Comments on the Applicant's Response to my Deadline 8 Submission - by Dr David Moore.

Dr David Moore MA (Cantab) PhD CEng FIMechE
Unique Reference Number: 20040614

Part 2 of 3 - Investigation

Figure 1. DEFRA Round 4 - Daytime Road Noise $L_{Aeq16hr}$

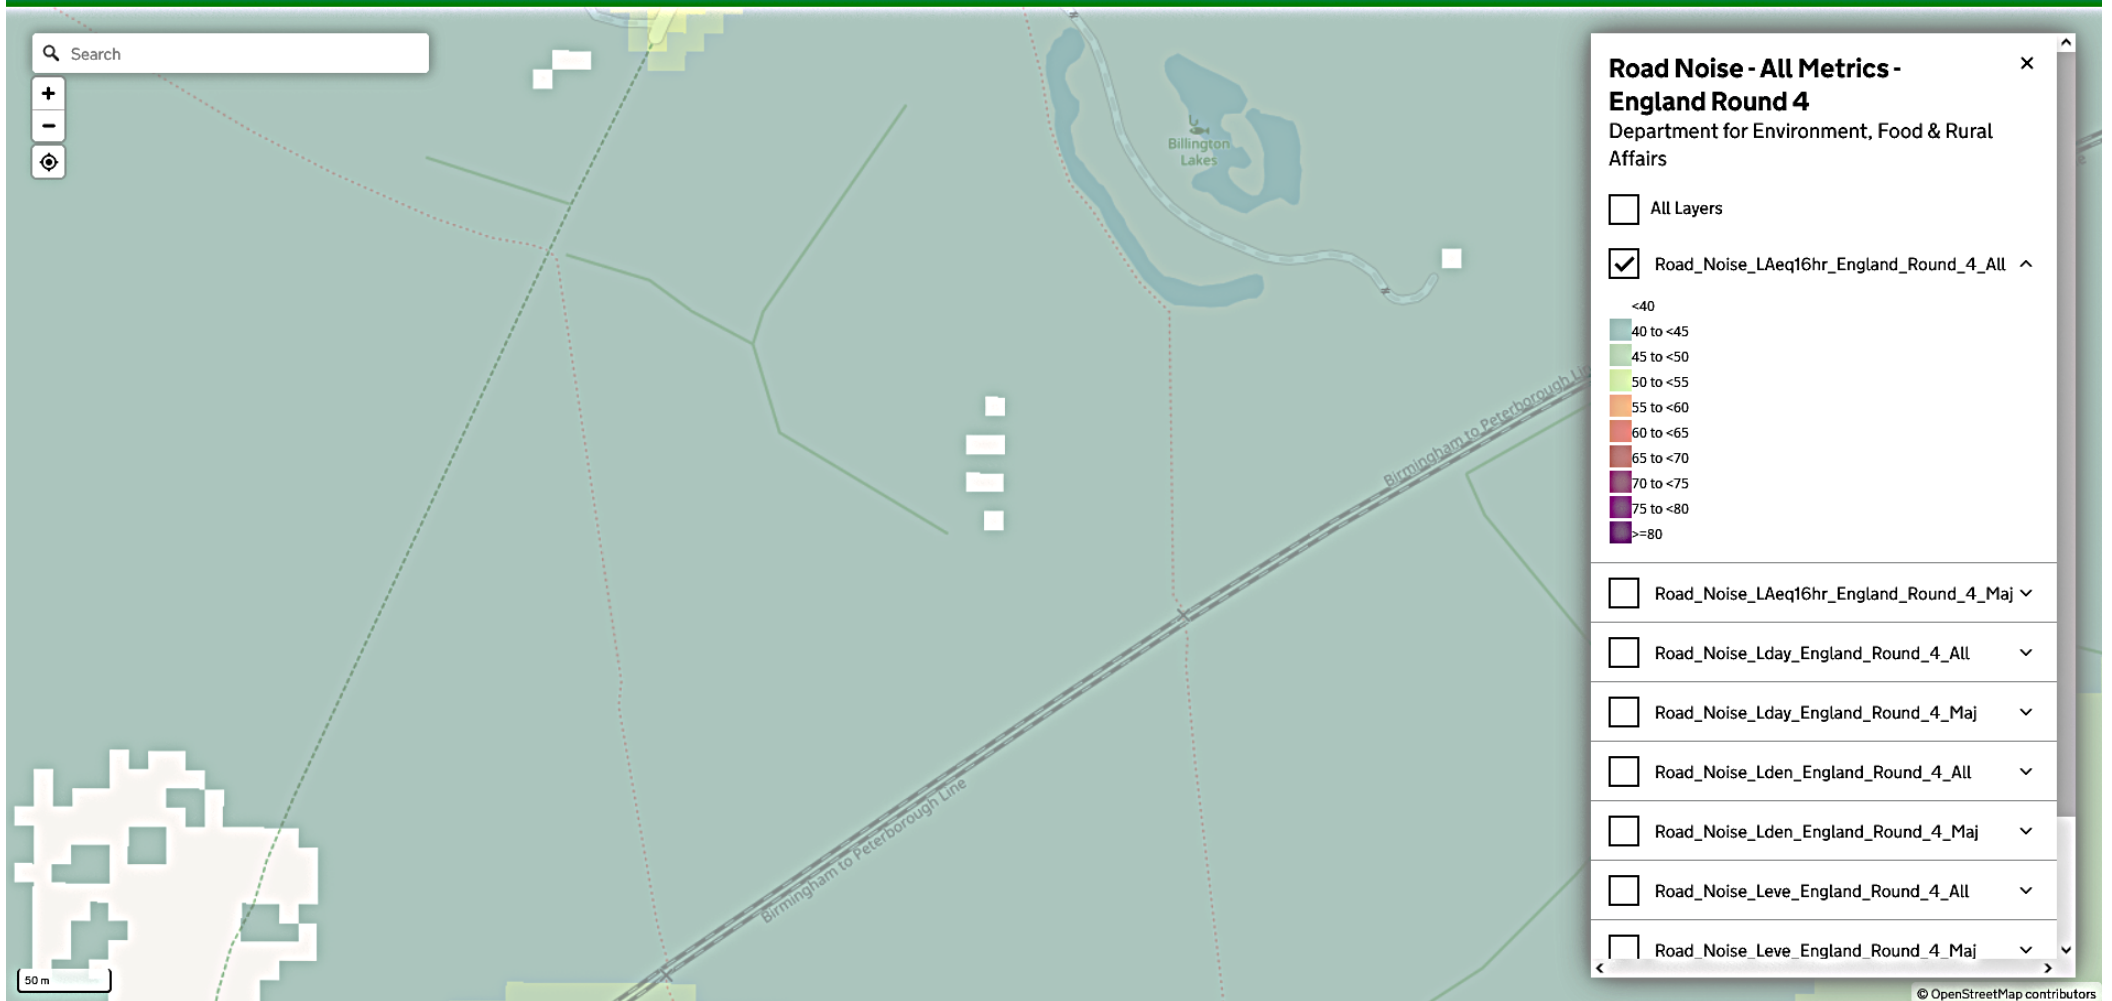
Taking the **Road** Noise at the Billington Lakes location first, it may be seen in Figure 1 below that the DEFRA Round 4 Daytime Road Noise $L_{Aeq16hr}$ is in the form of a very flat Noise Contour, with a Noise level at Billington Lakes in the range of 40dB to 45dB. And Figure 2 indicates that the DEFRA Round 4 Night Time Road Noise Level L_{night} has a similar very flat Noise Contour, with a Noise level at Billington Lakes in the range of 35dB to 40dB.

So just by comparing these two sets of numbers it is immediately obvious that there are large errors between the DEFRA and Tritax's Road Noise levels, amounting to around 13dB for the Daytime Road Noise levels, and increasing to around 16dB for the Night Time Road Noise levels.

Figure 3. DEFRA Round 4 – Site Map, showing NMP4 and Billington Lakes Noise Monitoring Positions and Positions of Sectional Views

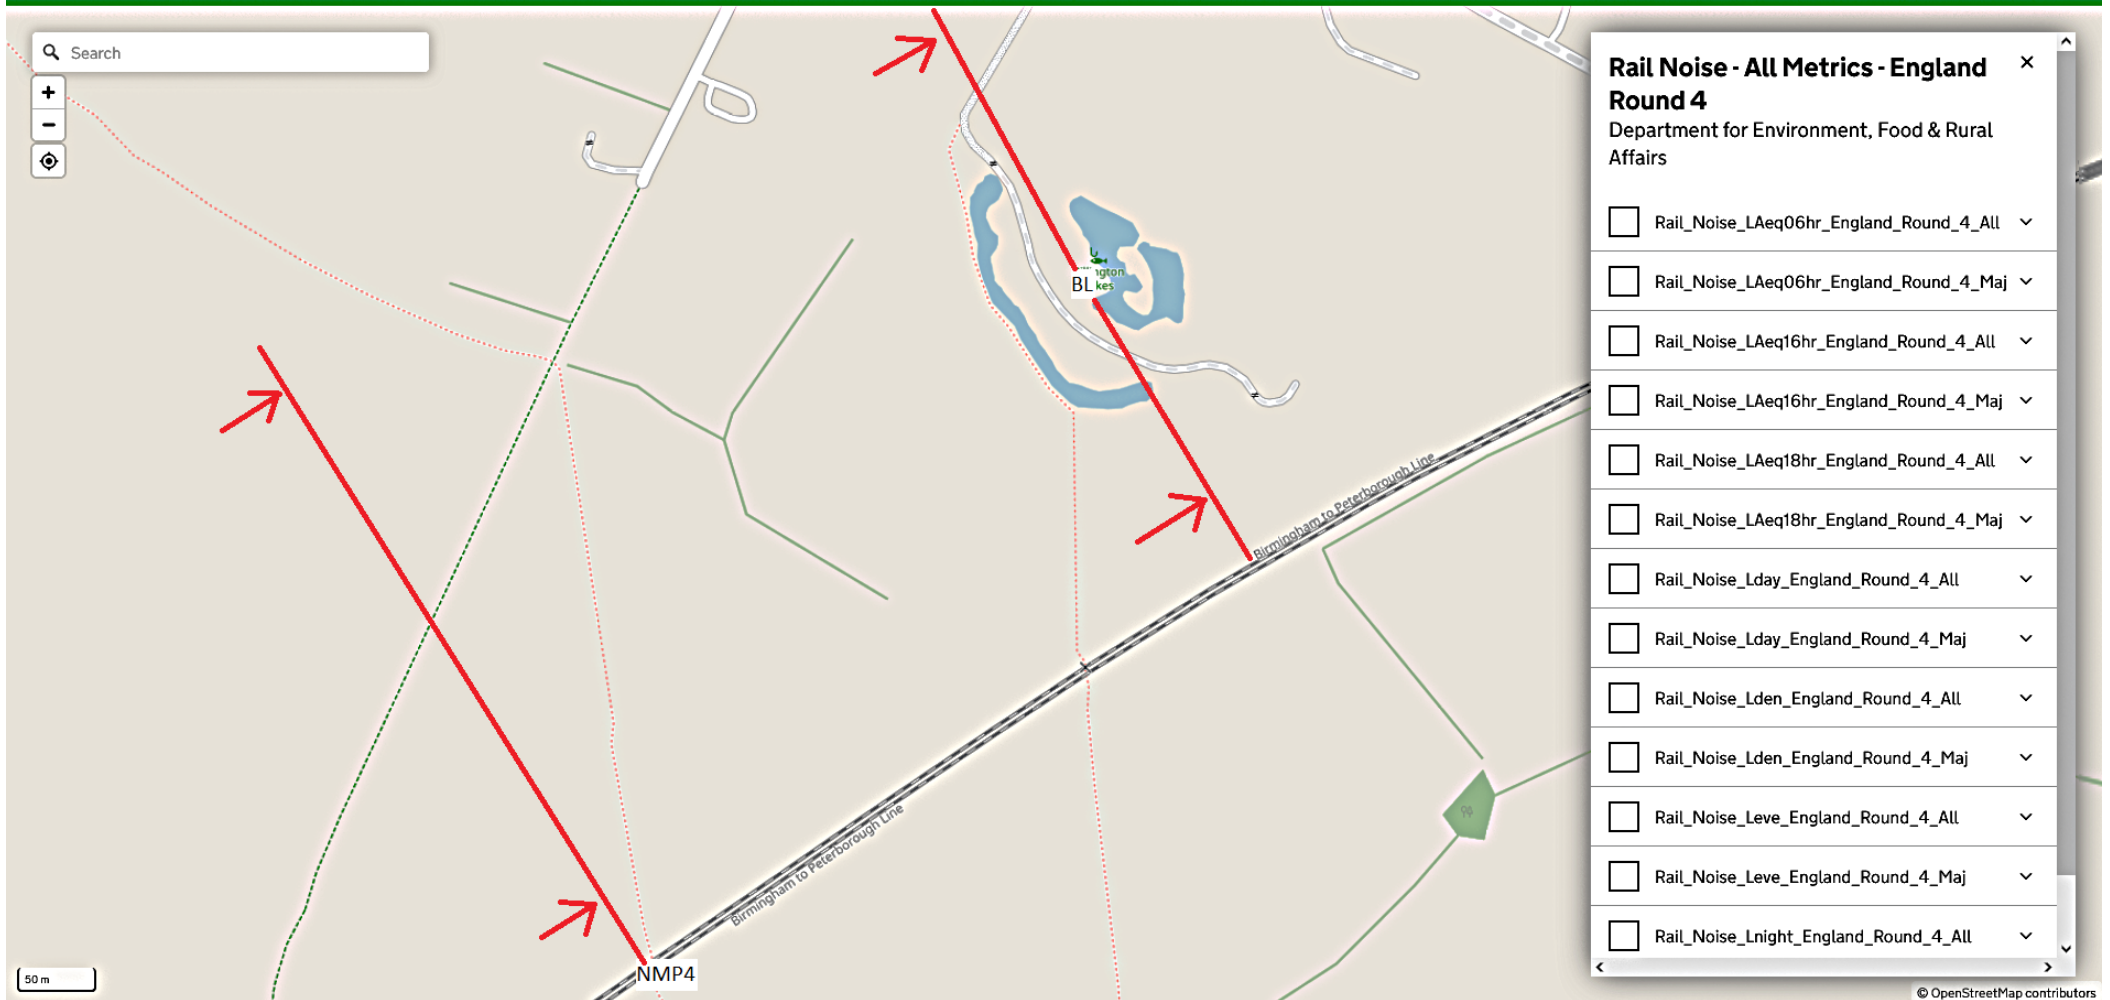
[These flat Noise Contours are of course very easy to understand and to compare with one another. And in Figure 3 below I have also shown a Site Map that I have taken from the DEFRA previewer to help you get your bearings. This shows the features on the ground much more clearly than the Noise Contour Maps. I have also marked on the Site Map the positions of the Billington Lakes and NMP4 Noise Monitoring Positions, together with some other features which I will refer to later].

[The locations of Billington Lakes and NMP4 are indicated on the Site Map in Figure 3. Figure 3 also indicates the positions of the typical Sectional Views through Billington Lakes and NMP4].

Figure 4. DEFRA Round 4 – Daytime Rail Noise $L_{Aeq16hr}$

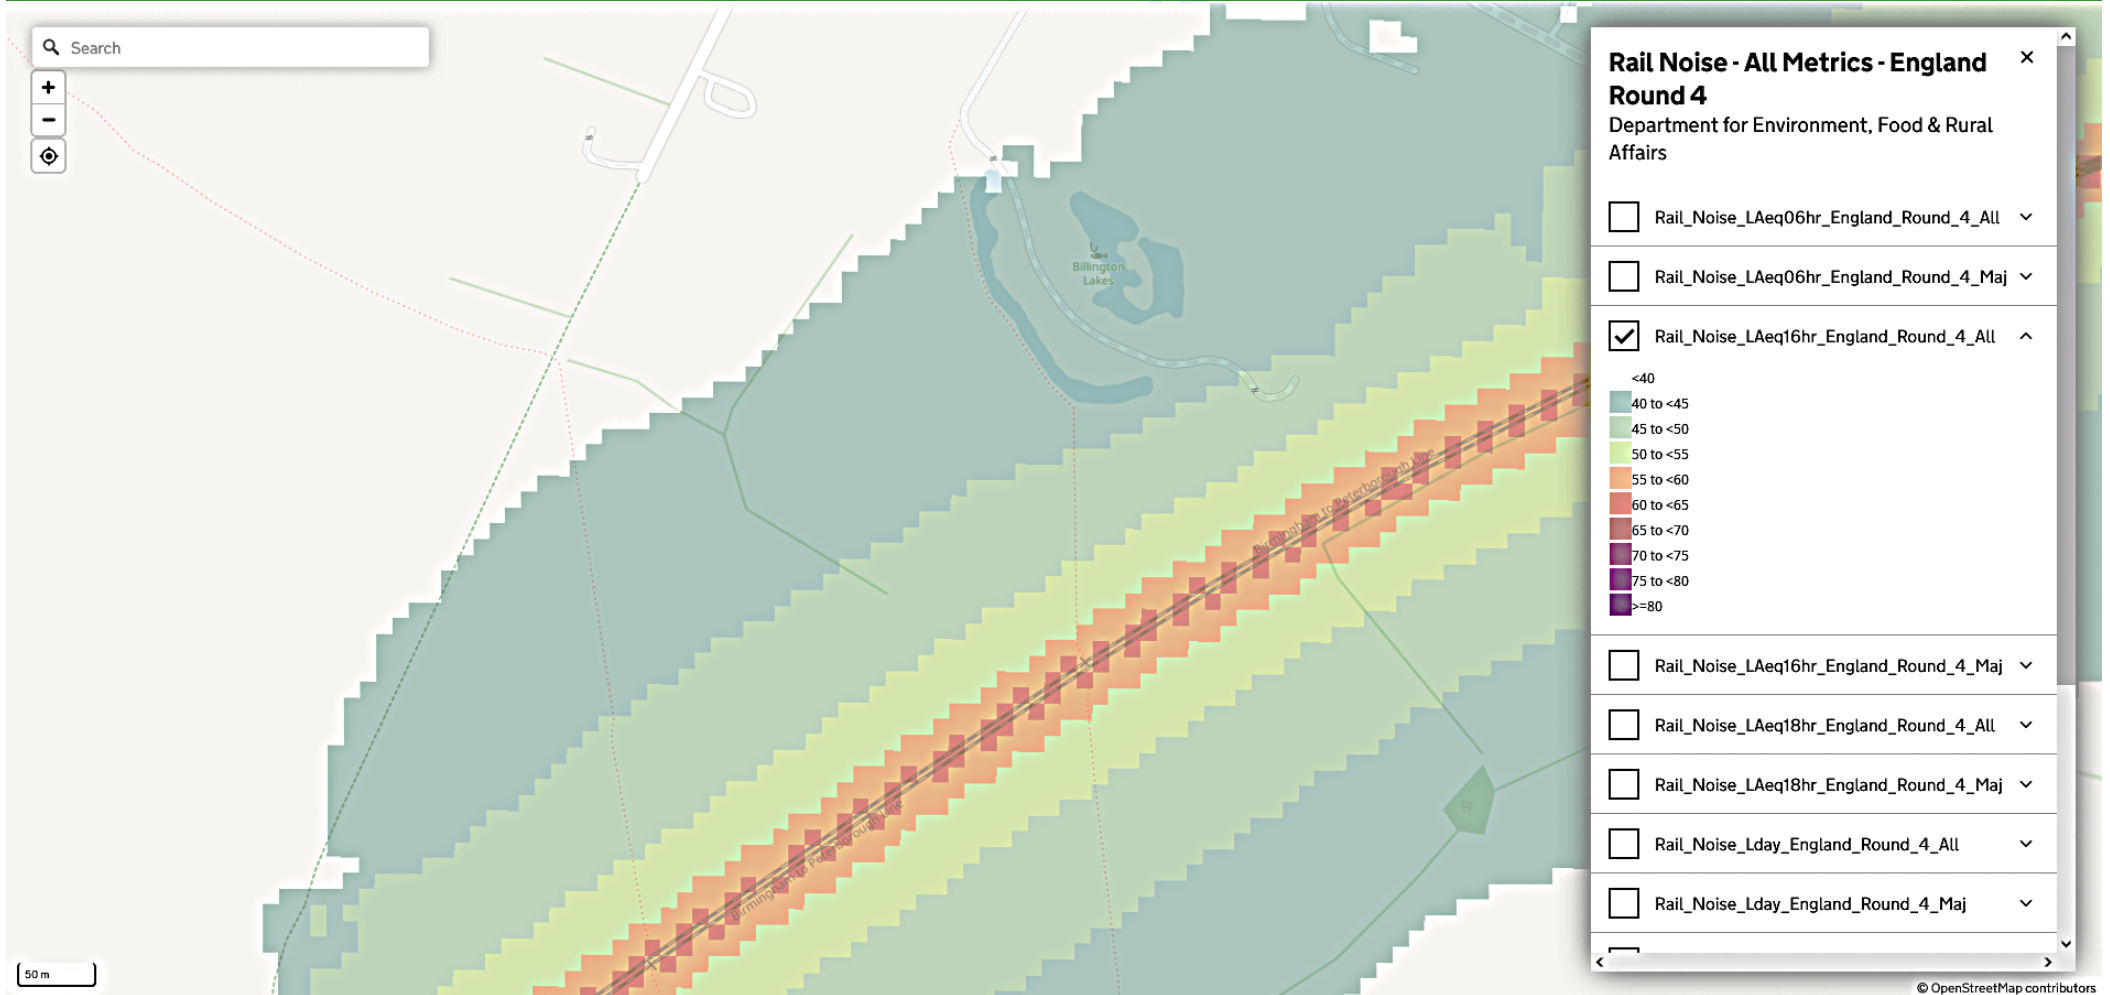
Turning now to the **Rail** Noise, Figure 4 below shows the DEFRA Round 4 Daytime Rail Noise level $L_{Aeq16hr}$ at Billington Lakes to be in the range of 40dB to 45dB. And Figure 5 shows that the DEFRA Round 4 Night Time Rail Noise level L_{night} at Billington Lakes is in the range of 35dB to 40dB.

Again, by comparing these two sets of numbers it is immediately obvious that there are large errors between the DEFRA and Tritax's Rail Noise levels, amounting to around 8dB for the Daytime Rail Noise levels, and increasing to around 13 dB for the Night Time Rail Noise levels. [The Daytime error is smaller because of the assumption made].

With reference first to **Daytime** Rail Noise, it can be seen in Figure 4 that the DEFRA Round 4 Daytime Rail Noise Contours follow a continuous and uniform pattern of banding along the length of the track, with only very minor variations apart from the bridge over the tracks at Burbage Common Road. Indeed, it can be seen that the DEFRA Round 4 Rail Noise Contours in the regions of Billington Lakes and NMP4 are sensibly identical.

Figure 5. DEFRA Round 4 – Night Time Rail Noise L_{night}

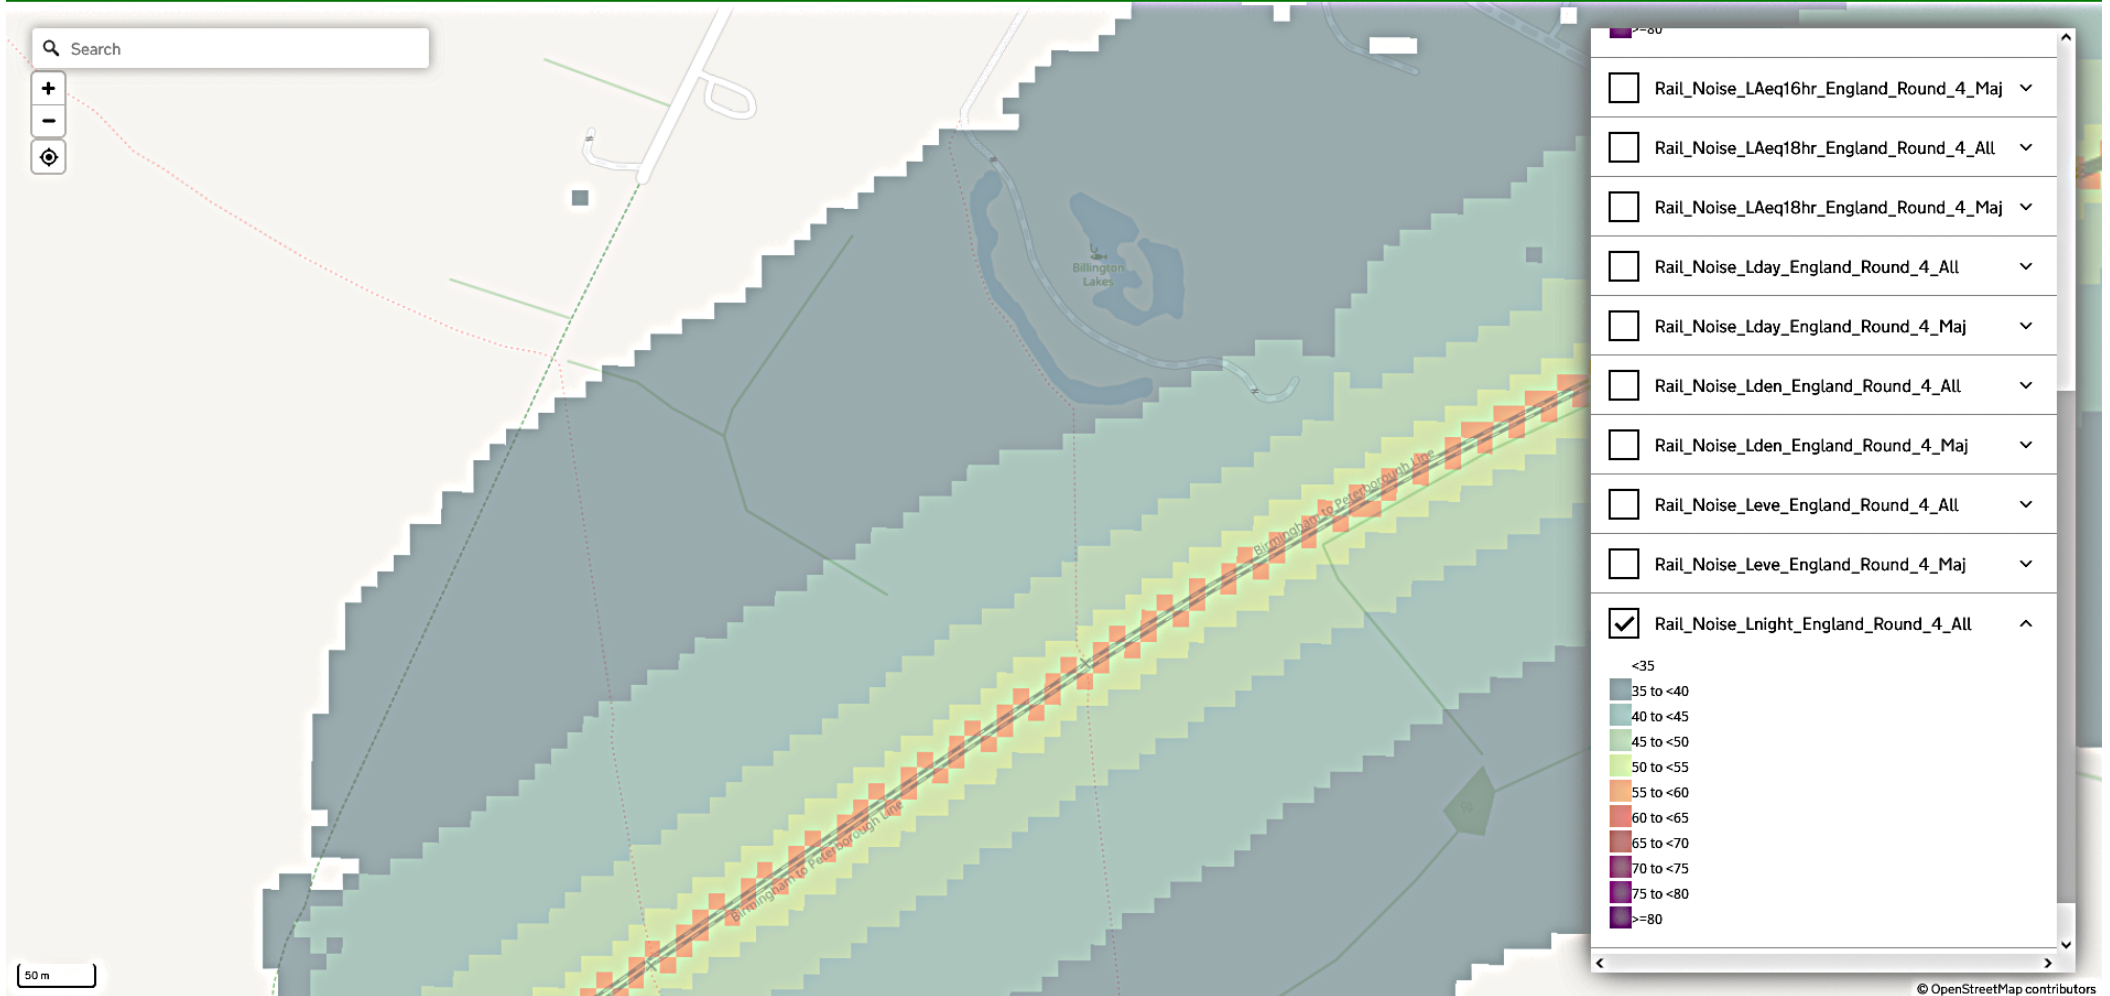
Turning now to the **Night Time** Rail Noise, it can be seen in Figure 5 that the DEFRA Round 4 Night Time Rail Noise Contours, although of course lower than the Daytime ones, display the same continuous and uniform pattern of banding along the length of the track.
